December 7, 2021

**NRHS ANNEX ROOF REPLACEMENT
For
North Rockland Central School District
MSA File No. 41056**

Re: ADDENDUM NO. 1

106 HANCOCK ROAD
TIBBLES, NY 10984

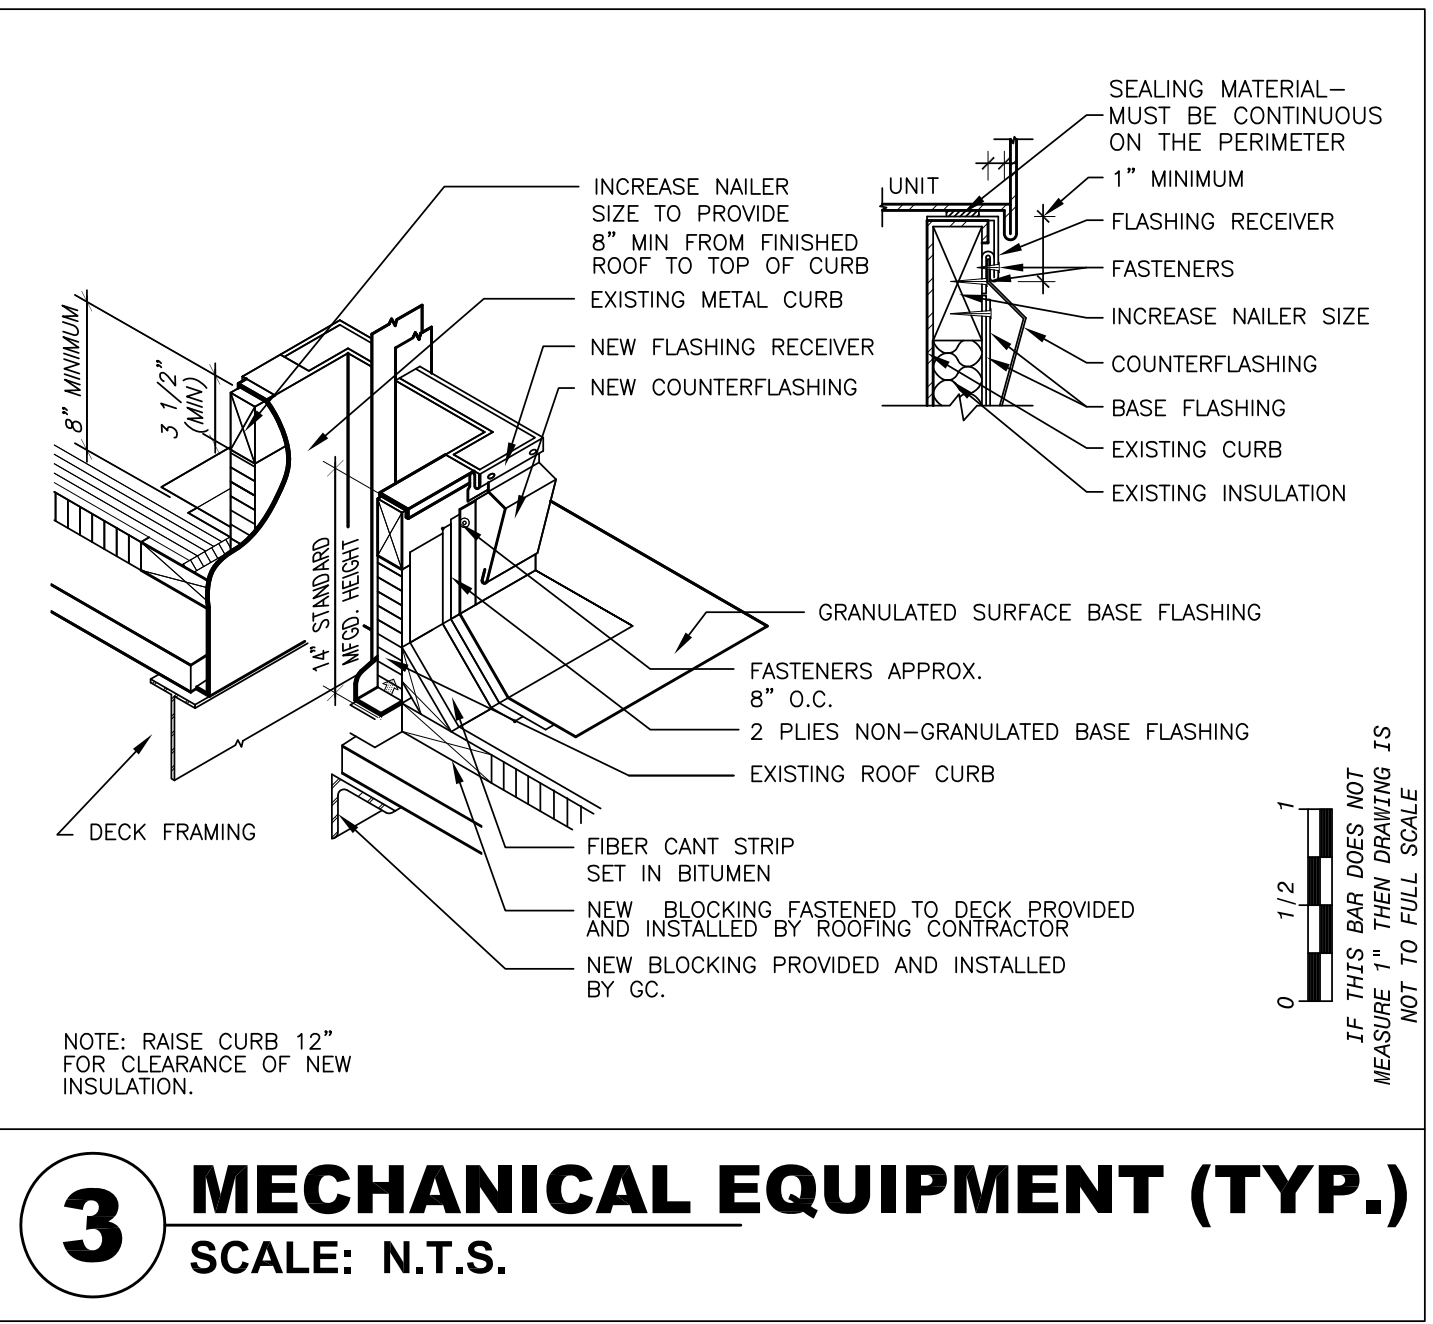
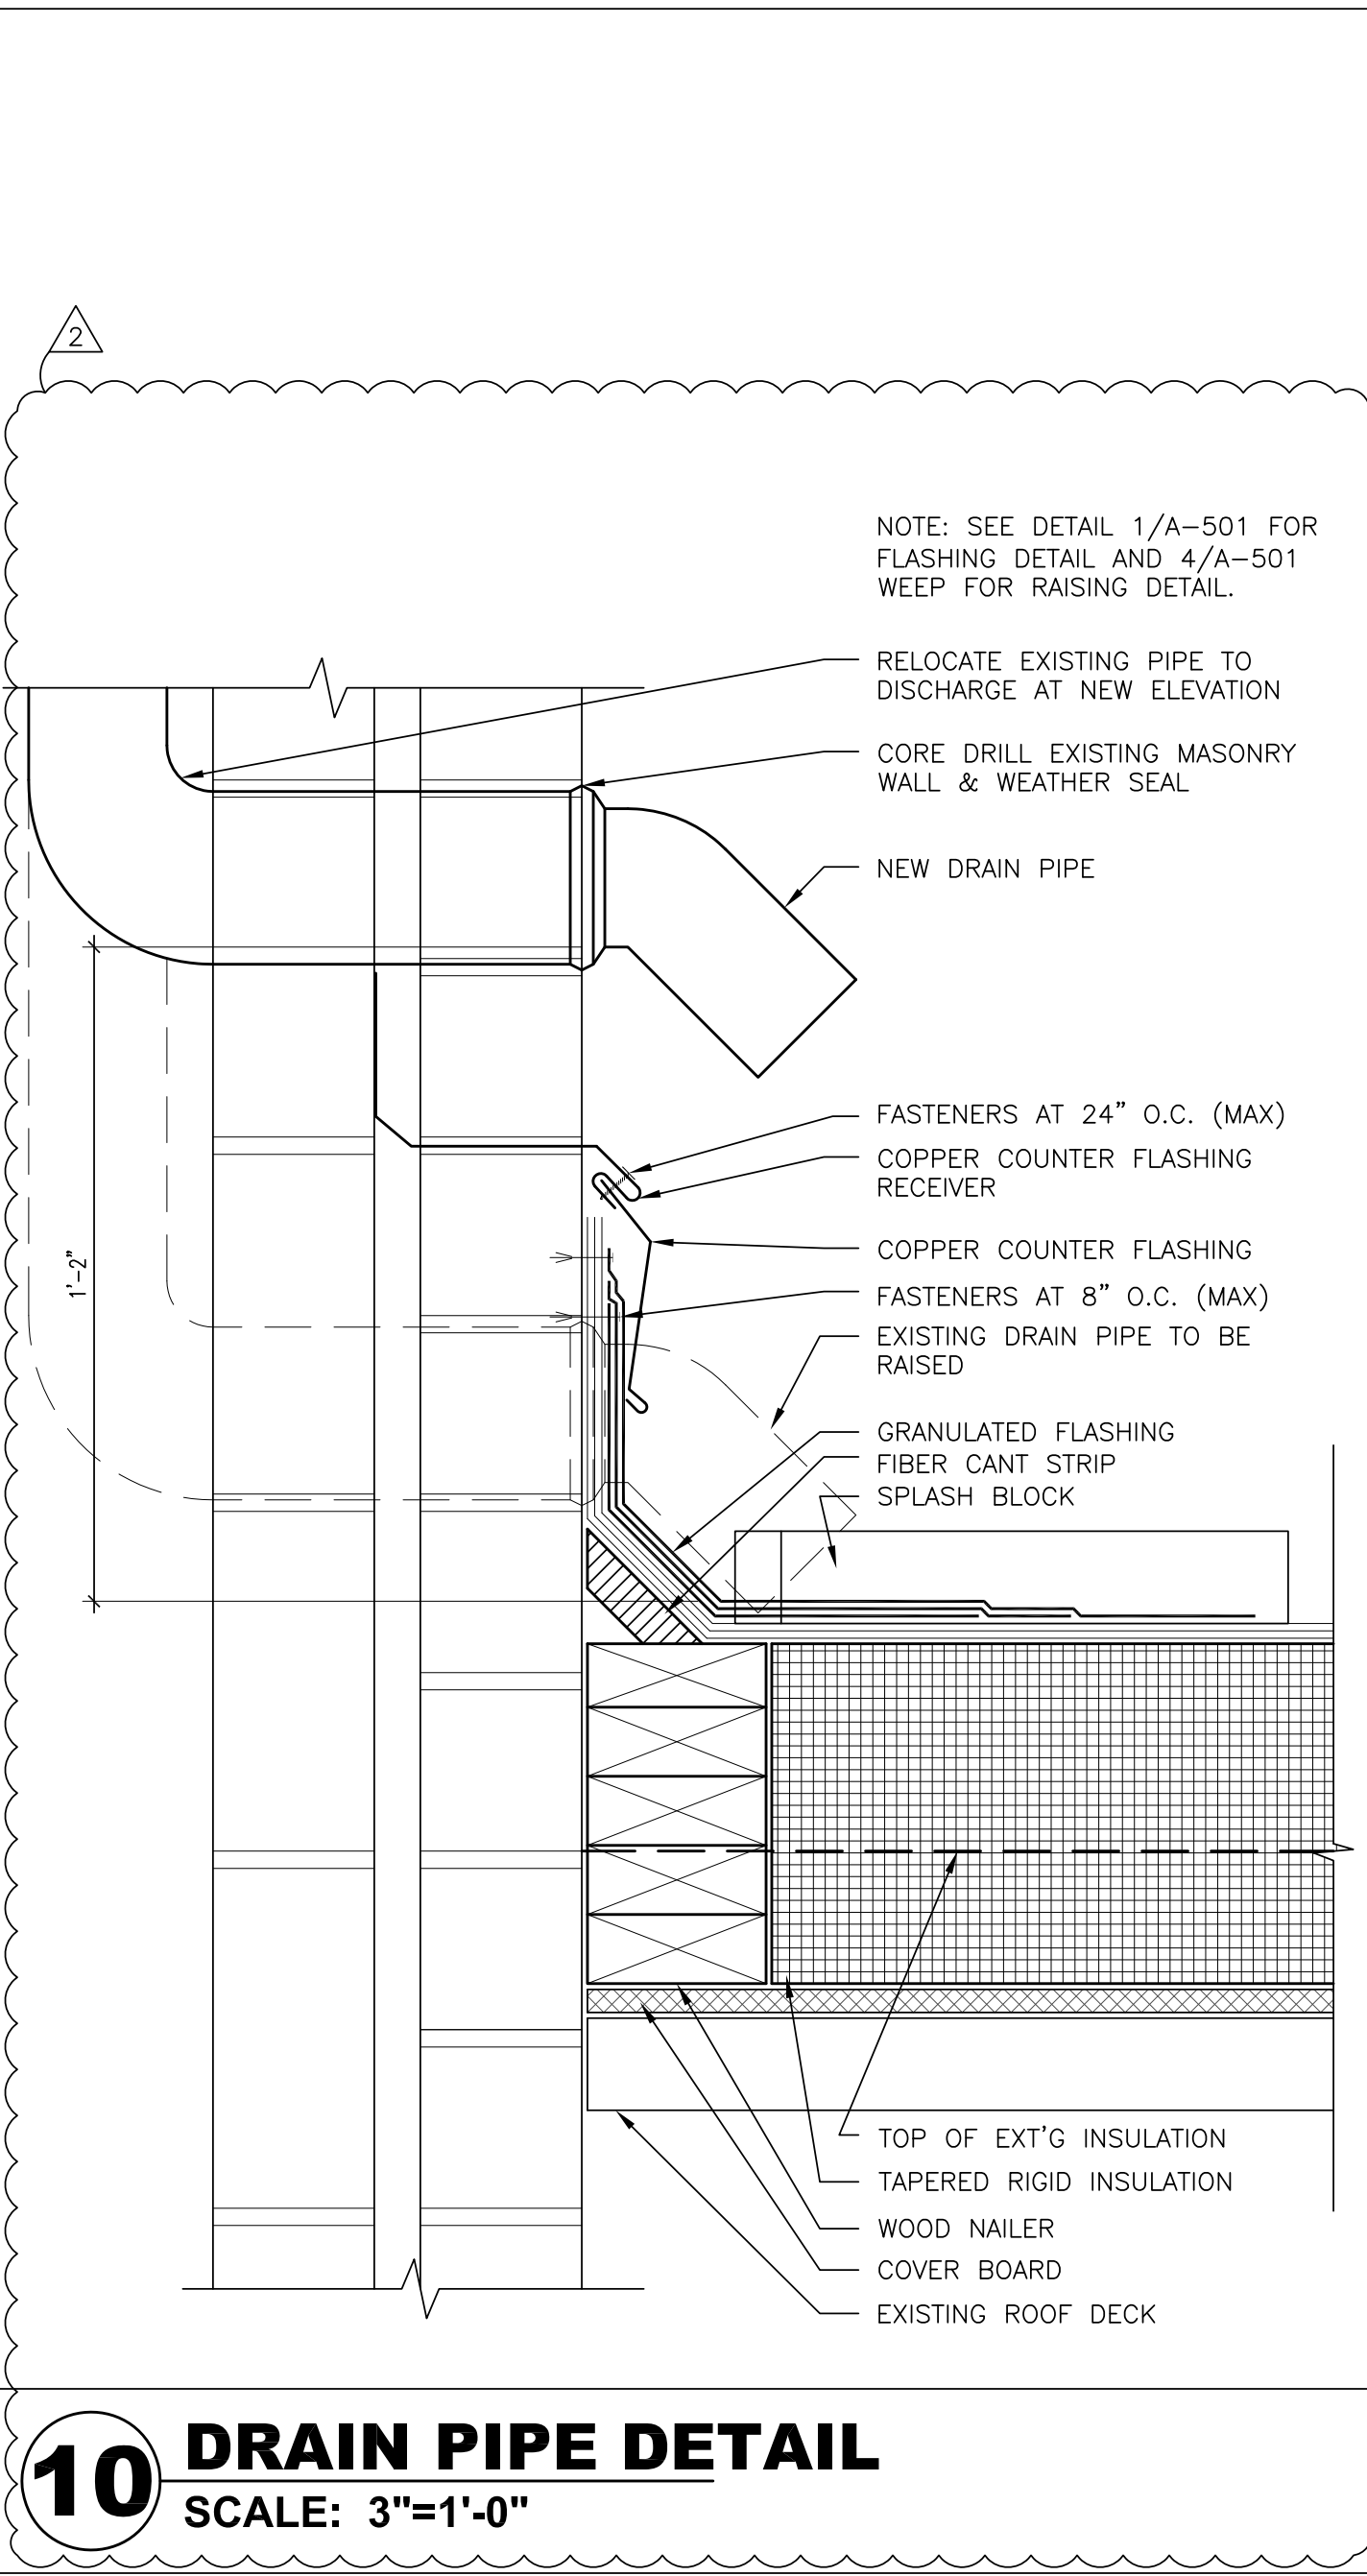
- 6) Additional pipe raising detail is provided. Detail 10/A-500 has been added and coordinated with drawing A-100. Use attached revised drawing A-500 Roof Details.
